COMMISSION FOR HISTORICAL & ARCHITECTURAL PRESERVATION

STAFF REPORT

REQUEST: Final Review for New Seven-Story Structure

ADDRESS: 1208-1226 E. Baltimore Street (Jonestown Historic District)

Image 7: Window jamb and setback detail, 1208-1226 E. Baltimore Street, Colimore Architects, August 2, 2018

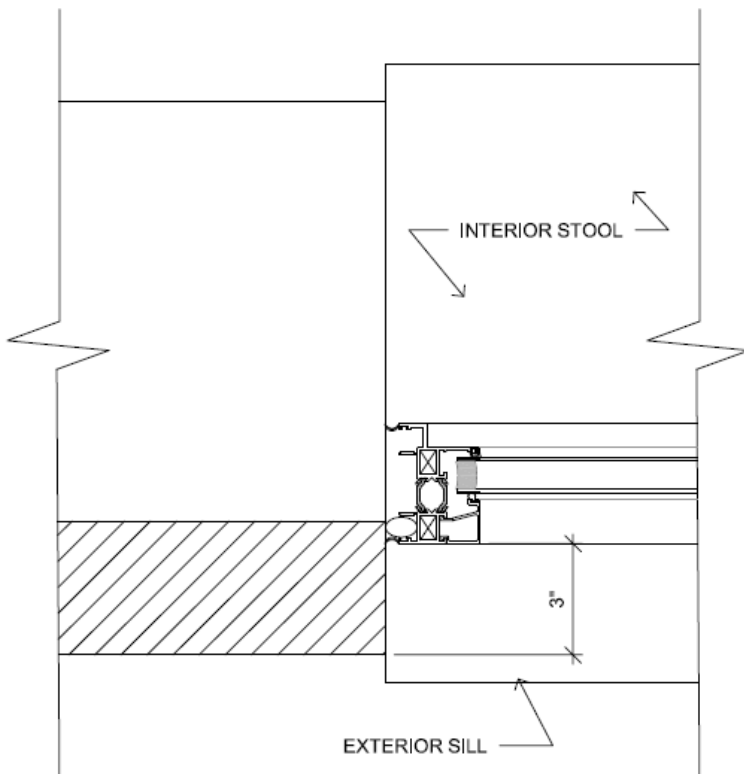
Commission recommendation: Examine including operable windows. Also provide details on reflectivity of glass, depth of windows within masonry, and depth of muntins. The use of shadow as a design element is encouraged.

Applicant response: The architect indicated that use of operable windows was “being considered” by the owner, but programmatically, given the clientele, there is a question whether even windows that open a fixed amount would be accepted. The architect has provided window detailing that he says more accurately conveys the design intent—to have different widths of the vertical and horizontal muntins. Two basis of design drawings were provided showing vertical muntins 4 ¼’ and 5” wide and horizontal muntins 3 ¼” wide (*Image 6*). Window jamb detail was also provided, showing the proposed set back of the window frame from the exterior wall at 3” with the glass set back from the window frame by an additional inch or more, per the architect, “providing depth and shadow lines” (*Image 7*). The applicant has selected a grey tint for the glass and low reflectivity.

Staff comment: Staff had in mind a tilt-out awning window at the bottom of a window unit which could be opened only a set amount. While staff would prefer operable windows, staff would accept fixed windows if required by the owner. Staff would like to see the window tint color for final review and approval, recommending that the tint be minimal. Staff finds that the window setback detail is acceptable and has requested a perspective drawing in which the more recessed windows and the differing horizontal and vertical muntins are applied.

- 1) Work with staff to determine the final window appearance and configuration.
- 2) Work with staff to determine the final appearance of the E. Baltimore Street entrances.

Image 8: Cornice detail, 1208-1226 E. Baltimore Street, Colimore Architects, July 20, 2018

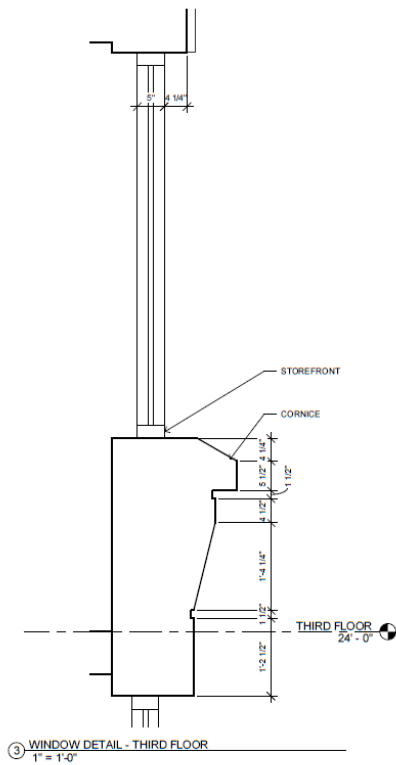
- Staff comment: Staff recommends approval of the two-color scheme.
- *Cornice and belt course—*
Commission recommendation: More review of cornice at second floor and roof edge at top of seventh floor; review the use of the belt course between the sixth and seventh floor, and perhaps add more depth and mass to the course.
Applicant response: The architect stated, “The cornice and belt course each have the same profile and show enough depth and width to provide relief and cast significant shadows.” The applicant provided details with dimensions (*Image 8*).
Staff Comment: The design details are acceptable.

Image 11: Railing detail, 1208-1226 E. Baltimore Street, Colimore Architects, July 20, 2018

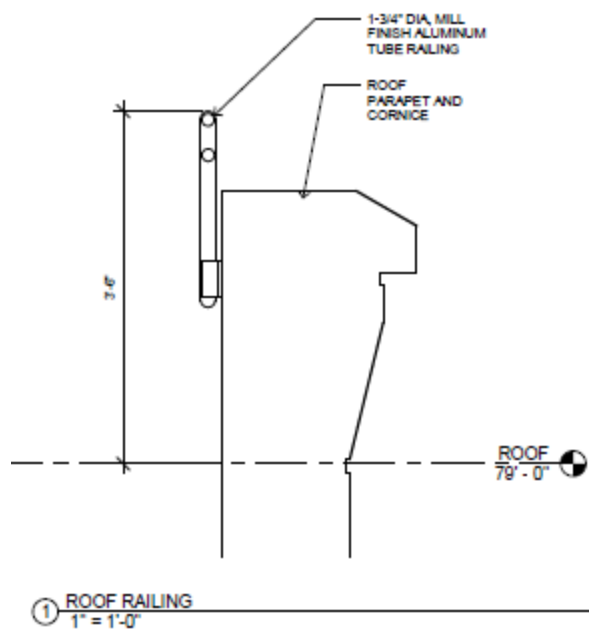
- *Rooftop terrace—*
Commission recommendation: More study of setback and provide railing detail.
Applicant response: The columns supporting the cover of the rooftop deck were initially modified to paired masonry columns, which staff still thought looked heavy and didn’t have any cap to relate them to the rooftop cornice. The architect subsequently proposed cladding them in a panel product and painting them white. Skylights were added to the terrace roof. At the sides, the terrace cover was reduced, setting it in from the east and west elevations by one bay width (*Images 9 & 10*). Railing detail was provided (*Image 11*).
Staff comment: Staff finds the modifications meet the recommendation.

Image 13: Revised main entry detail, 1208-1226 E. Baltimore Street, Colimore Architects, July 20, 2018

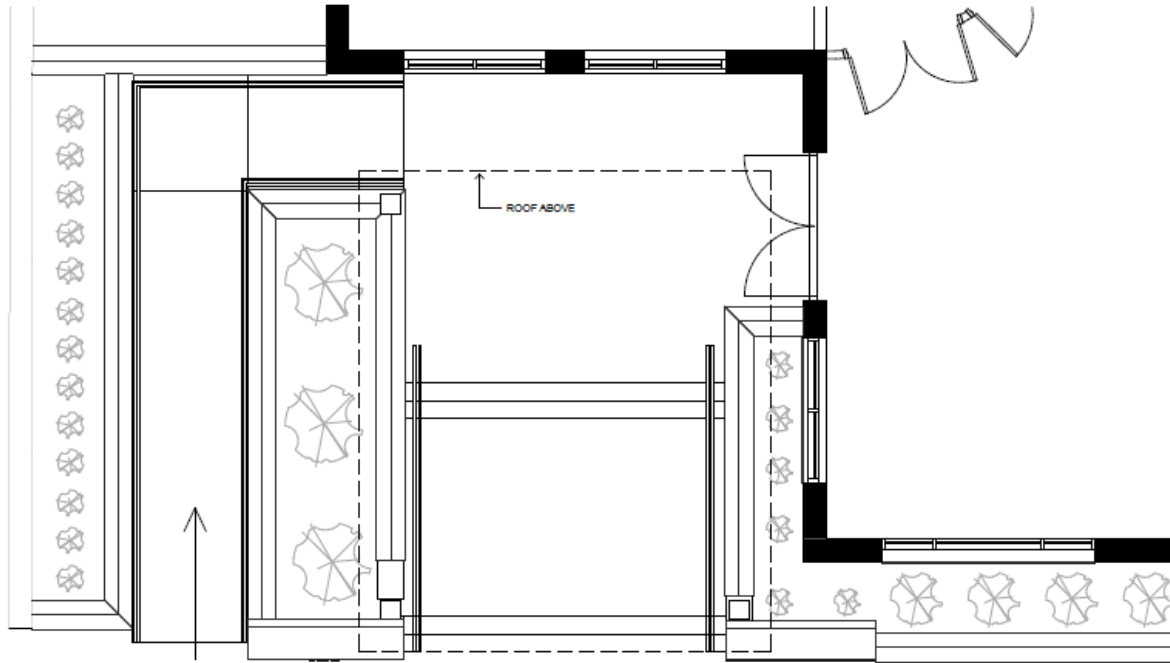
- *Signage—*
Commission recommendation: Address signage at entrance.
Applicant response: The architect modified the signage and added a cap to the entrance canopy, but this was revised further after discussions with staff and the architect provided detail drawings of the entry (*Images 12 & 13*). A new secondary entrance was added to the Baltimore Street façade in response to the owners’ request to have a separate “Residents only” entrance for those already begin served by and living in the facility.
Staff comment: The revised main entry design with the flat but prominent roof and the individual standing letters for the signage is acceptable. Staff questions whether the new secondary entrance at the Baltimore Street elevation is necessary, but as a “residents only” entrance it makes some sense. Staff recommends that this be thought through some more.

Image 14: McKim Park Access – Detail, Colimore Architects, July 20, 2018

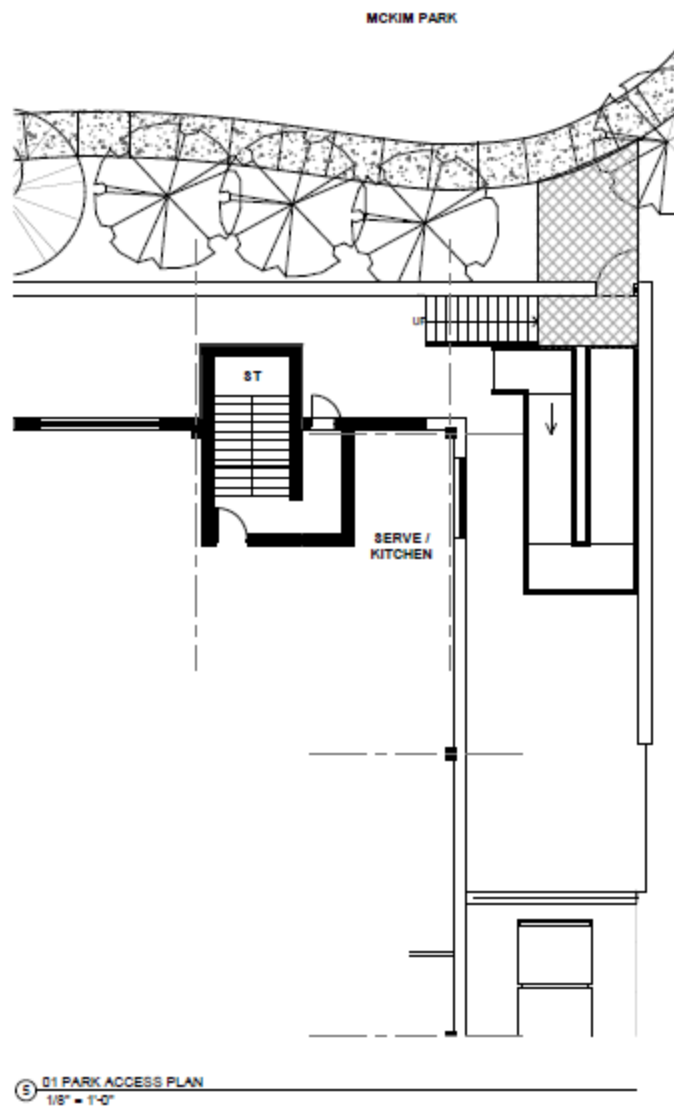
- *McKim Park—*
Commission recommendation: Explore the connection of the project to the new McKim Park to the north.
Applicant response: The architect provided new floor plan details showing a stair and accessible ramp from the northeast corner of the ground floor rear terrace, up to the level of the park—given the difference in grade (*Image 14*).
Staff comment: The plan details meet the Commission recommendation.
